UNITED STATES PATENT AND TRADEMARK OFFICE

APPLICATION NO.	FILING DATE	FIRST NAMED INVENTOR	ATTORNEY DOCKET NO.	CONFIRMATION NO.
10/534,835	05/13/2005	Hideobu Hamada	2005-0795A	6722

Office Action Summary

DETAILED ACTION

wherein the exiting beam is made to exit from the optical transmission line, and the output signal corresponding to the exiting beam is outputted (column 34, lines 6-11). Figure 29 of the '159 patent is reproduced below.

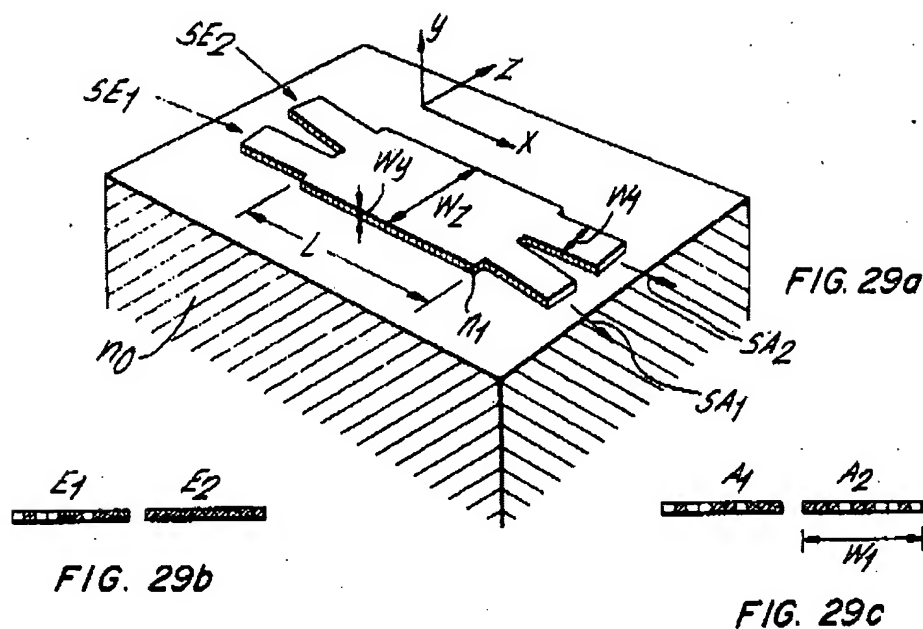
In re claim 1, the '159 patent shows in Figure 29 an optical device that connects, by a signal beam, between an externally inputted input signal and an output signal to be outputted (column 33, lines 14-31), the optical device comprising:

an optical transmission line being sheet-form and including a refractive index distribution such that a highest refractive index part is provided in a direction of a thickness of the sheet and a refractive index does not increase with distance from the highest refractive index part in the direction of the thickness (column 33, lines 21-32),

wherein a signal beam corresponding to the input signal is made incident on the optical transmission line as an incident beam (column 33, lines 44-52),

wherein inside the optical transmission line, the incident beam is transmitted, in a direction of a length that is orthogonal to the direction of the thickness, in multiple modes having a plurality of eigenmodes in a direction of a width that is orthogonal to both the direction of the length and the direction of the thickness, and an exiting beam is generated by the plurality of eigenmodes interfering with each other in the direction of the length (column 22, lines 28-56), and

In re claim 14, the device shown in Fig. 29 of the '159 patent operates as a 1 x 2 splitting device and includes:

an incident surface SE_1 for making the incident beam incident;
an exit surface SA_1/SA_2 for making the exiting beam exit, and
the size in the direction of the length is inherently a value that satisfies the claimed expression because the transmission line of the '159 patent has the same physical structure and operates in the same manner to that claimed.
